# METROPOLITAN GOVERNMENT OF NASHVIELE AND DAVIDSON COUNTY

Metropolitan Historic Zoning Commission Sunnyside in Sevier Park 3000 Granny White Pike Nashville, Tennessee 37204 Telephone: (615) 862-7970

### STAFF RECOMMENDATION 105 Broadway August 18, 2021

**Application:** New Construction - Violation

Figure 1: The new structure

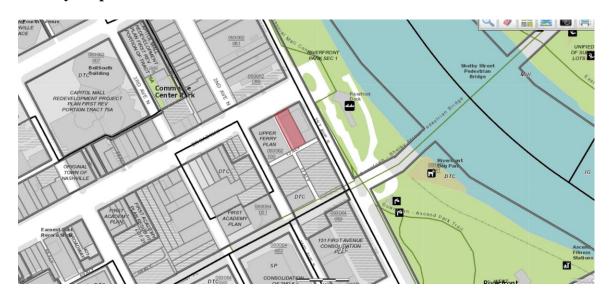
The violation is a one-story detached wood structure that faces Broadway and sits to the right of the building in space which previously was an alley. The structure is considered new construction and was constructed without a permit.

**Height and Scale:** The building is one-story tall with a single window facing Broadway and a door facing the alley. It is rectangular in shape with a pitched gambrel roof. Surrounding structures include two- and three-story masonry commercial buildings.

The design guidelines state that infill should be "constructed to a height that is compatible with the height of adjacent buildings." The building should also be a minimum of 30' tall and two stories in height (Guideline III.A.1) with the first floor being a minimum 16' tall (Guideline III.A.2 and C.4). The existing shed meets none of the requirements.

The building's overall massing is not compatible with the surrounding structures (Guideline III.C.1) given that it is significantly smaller than surround buildings and has different void to solid ratios. It also does not have three distinct parts (a base, middle and cap) as the guidelines suggest (Guideline III.B.3).

**Roof Shape:** The structure has a gambrel roof with metal sheeting. The buildings immediately surrounding the structure have flat and parapet roofs, as is common with commercial structures. Based on the guidelines, the roof of the structure should be compatible with those on surrounding historic structures. The project does not meet section III (E) of the guidelines.

**Proportion and Rhythm of Openings:** The building has a single window and a rear door with no additional openings. Based on the guidelines, the structure should have defined entrance (Guideline III.F.3). At least eighty percent of the first floor primary facade should also have openings (Guideline III.F.2). Lacking these, the structure should have similar or compatible window and door openings compared to the surrounding structures. This project does meet Section III.F for proportion and rhythm of openings.

Relationship of Materials, Texture, Details, and Material Color: The building was constructed with wood planks that sit flush to each other. Overall, the structure is left unadorned with no paint and no decorative elements. Wood is not used in the district as a primary cladding material and so does not meet section III.G of the guidelines. It is also not appropriate for structures to have large areas of featureless materials (Guideline III.F.6). Given the size of the building, the lack of ornamentation is less of an issue, but the overall materials are not compatible since the surrounding structures are predominantly masonry.

**Orientation:** The structure is orientated towards Broadway with a window facing the street. The primary door, however, is at the rear of the building. There is no traditional entryway or storefront as is seen with other commercial buildings in the district.

The guidelines state that a structure should have a recessed primary door that face the road (Guideline III.H). The main door for the structure, however, is on the rear and faces the alley and does not meet the guidelines.

Staff recommends disapproval of the shed building at 105 Broadway finding that the project does not meet section III for new construction. Staff recommends that the structure is removed within sixty (60) days of the Commission's decision.
